Kenavon Drive, Reading

Proposed Amendments

West Block and Middle Block Stage 4 Amendments, September 2021

West Block Proposed Amendments Drawing Comparison

Ground Floor Plan

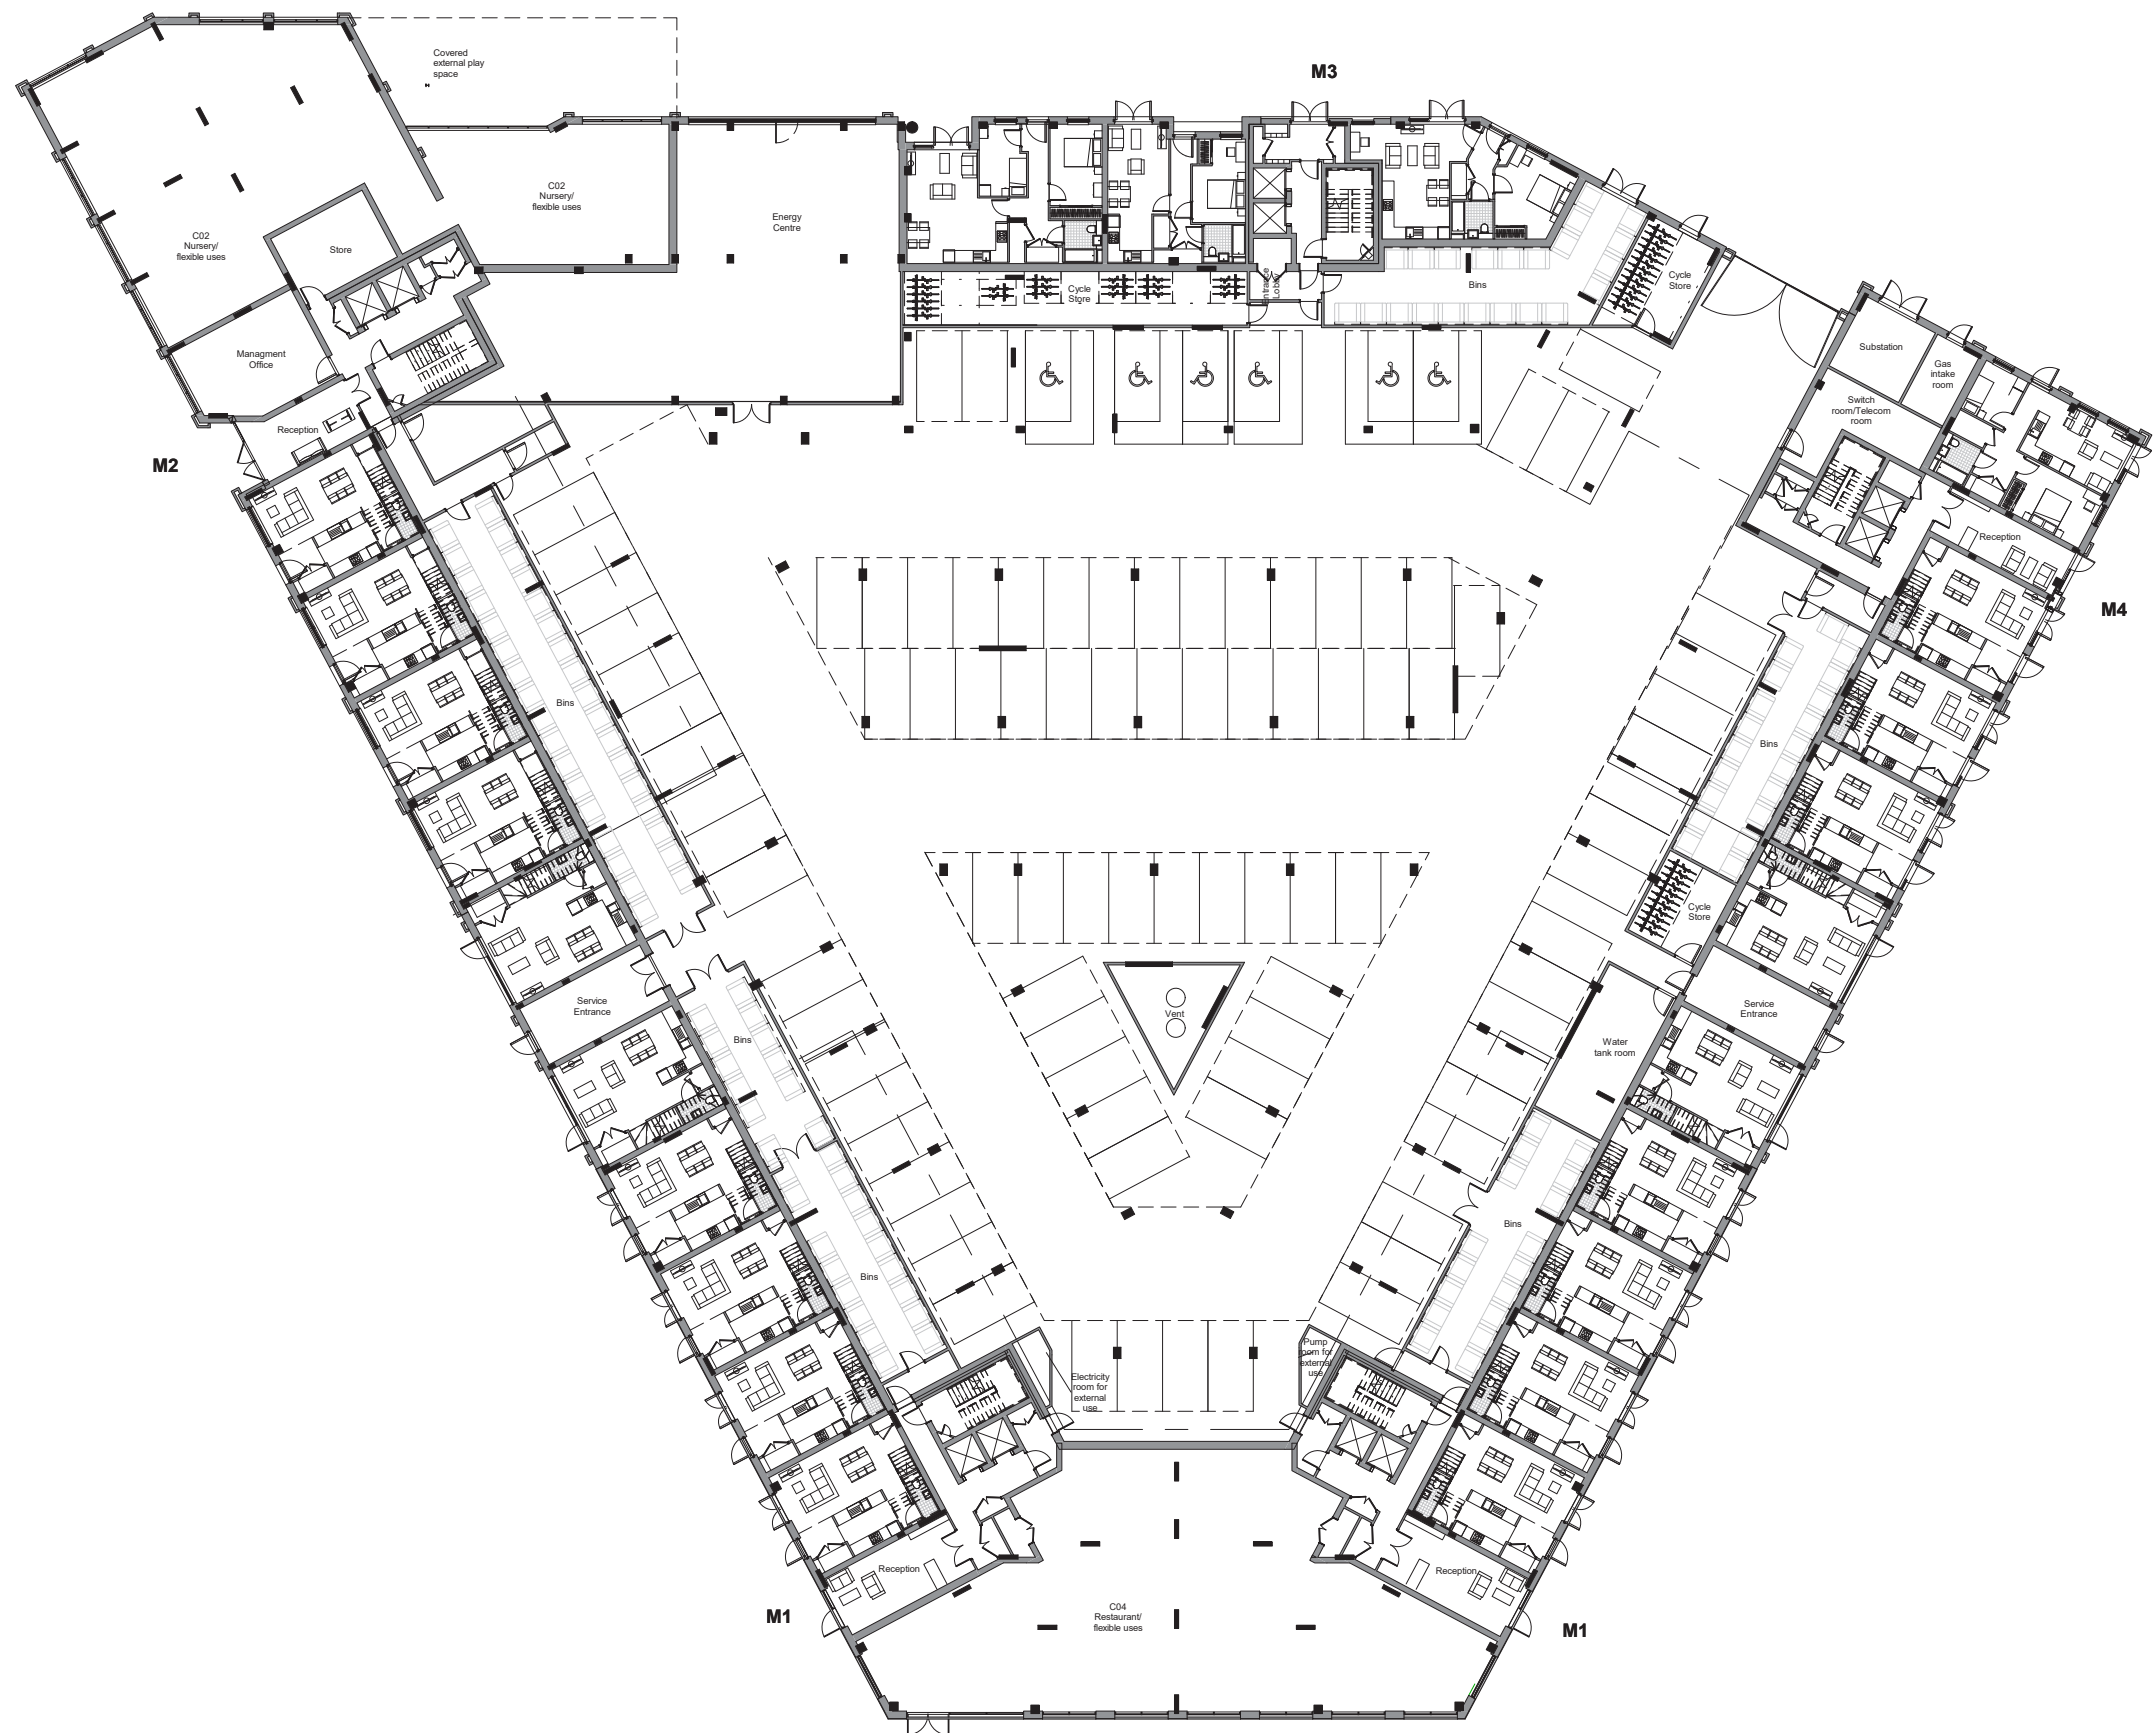
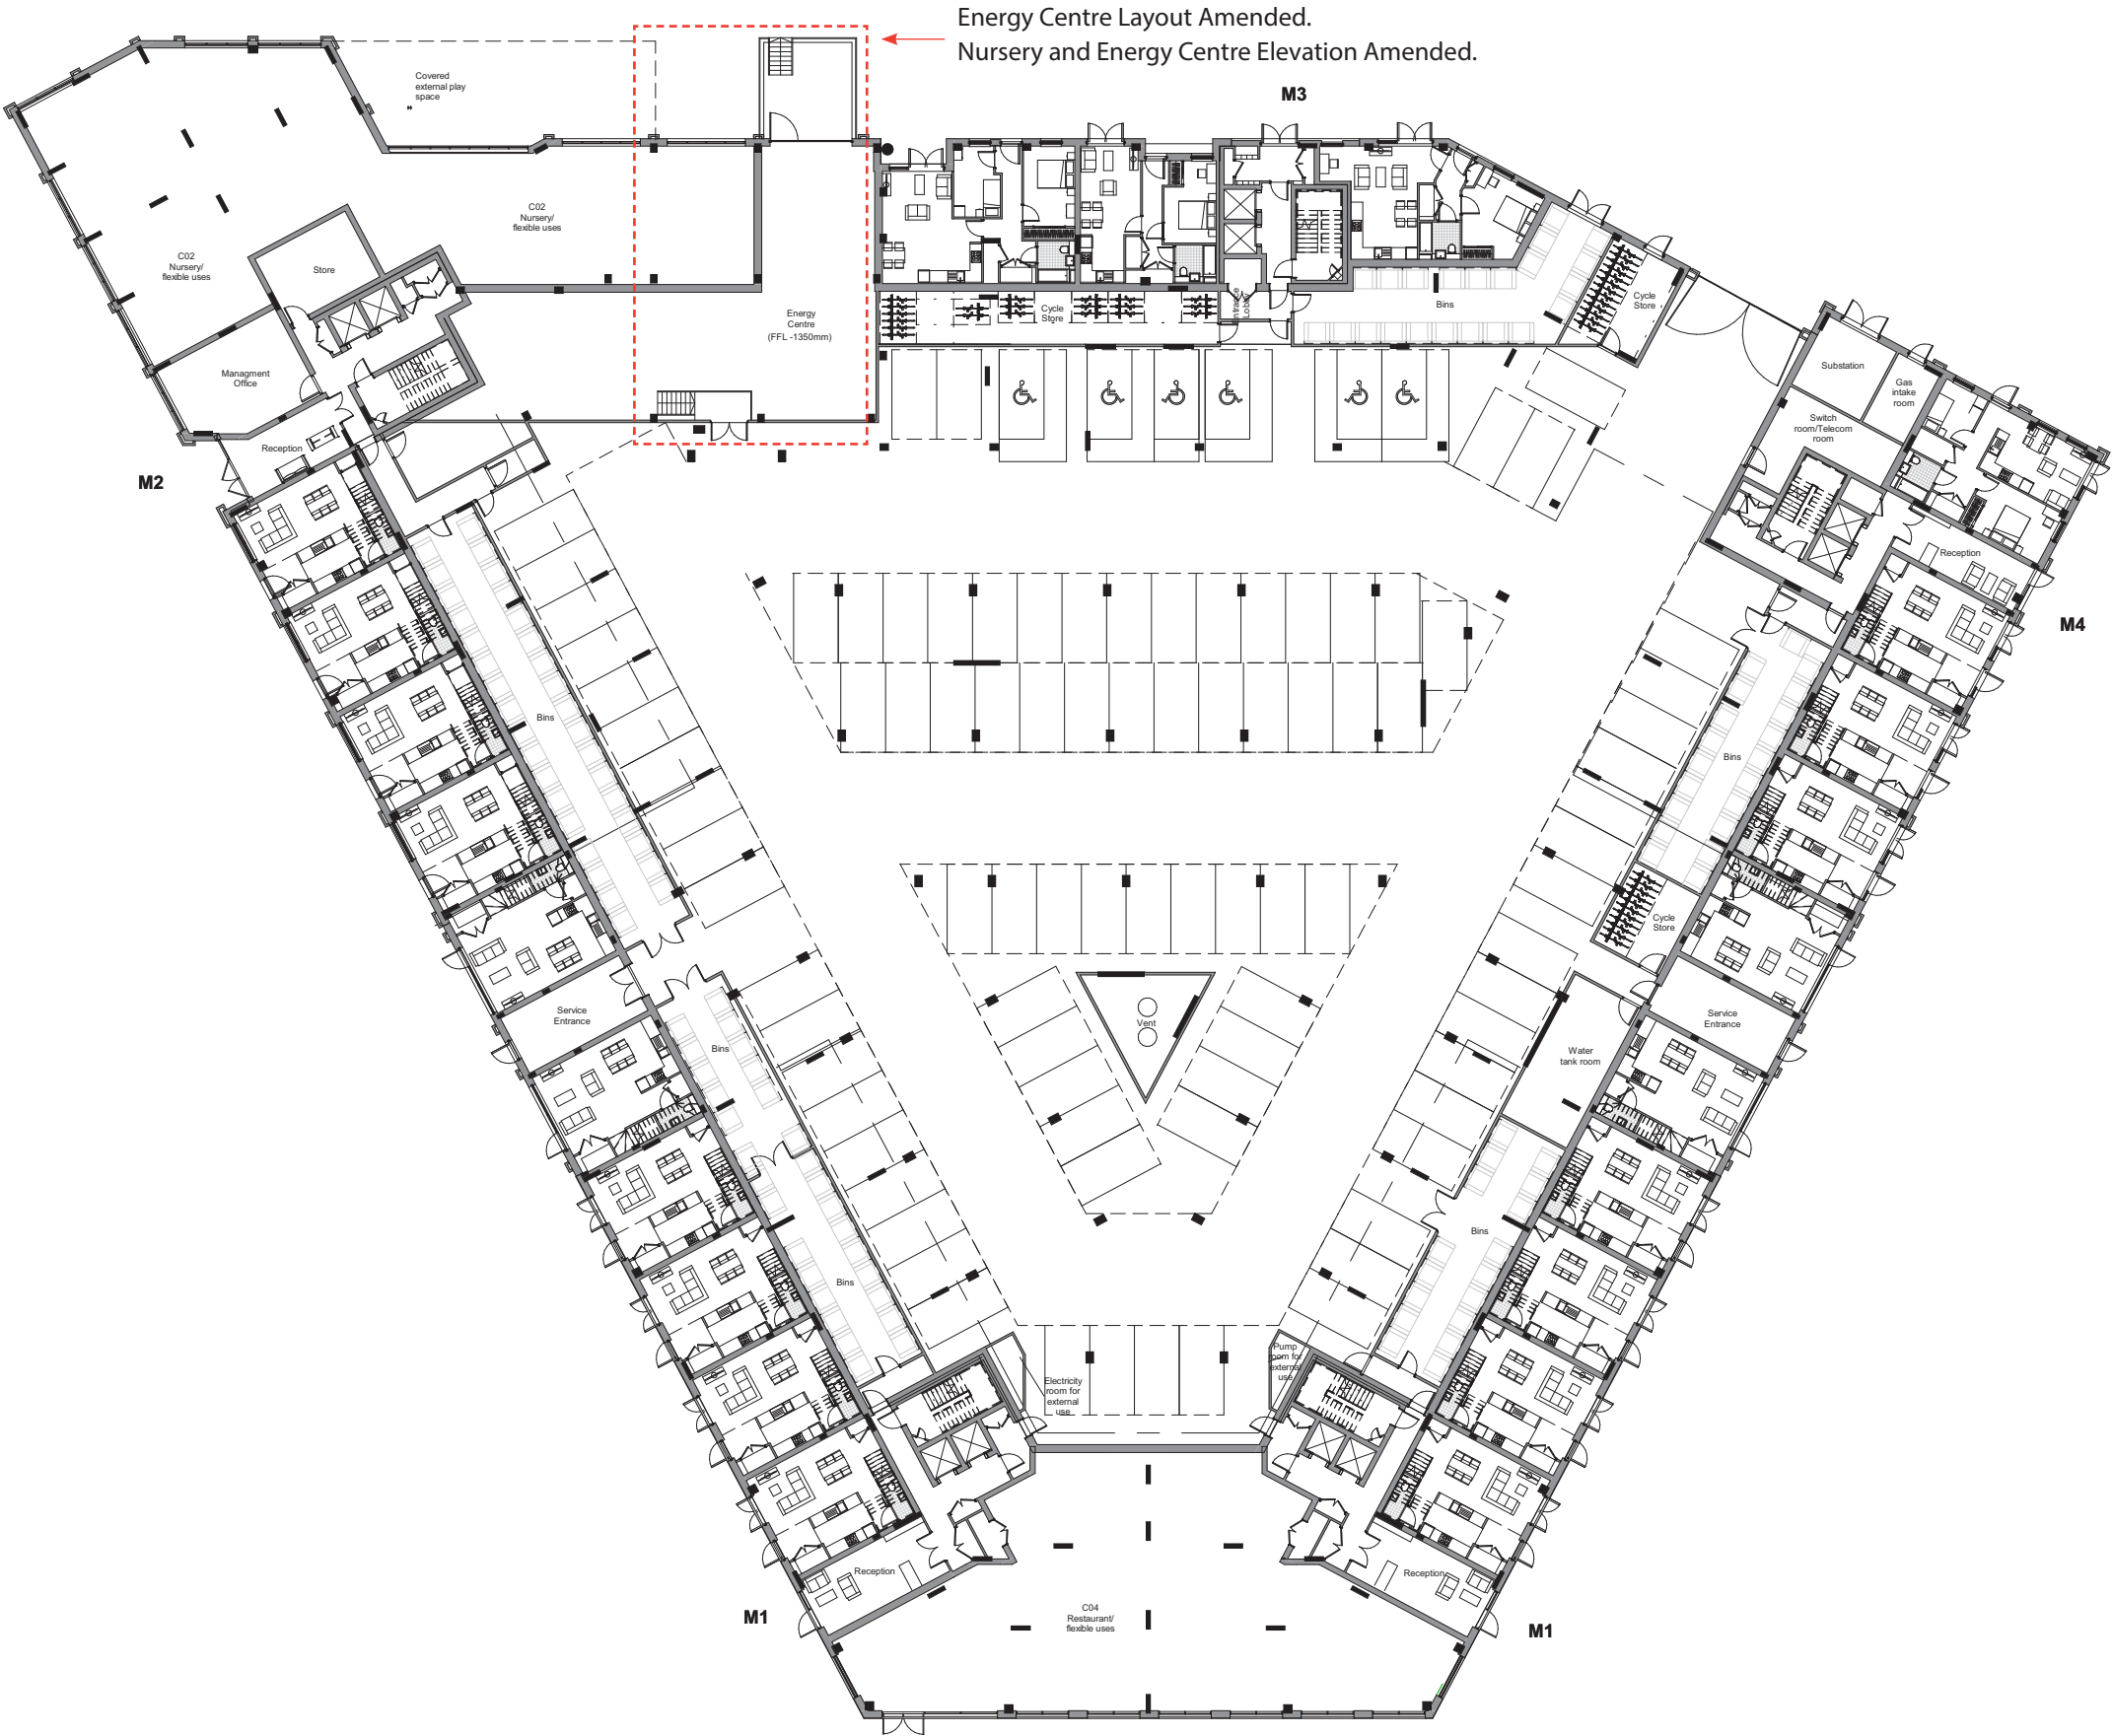
Nursery and Energy Centre Elevation Amended.
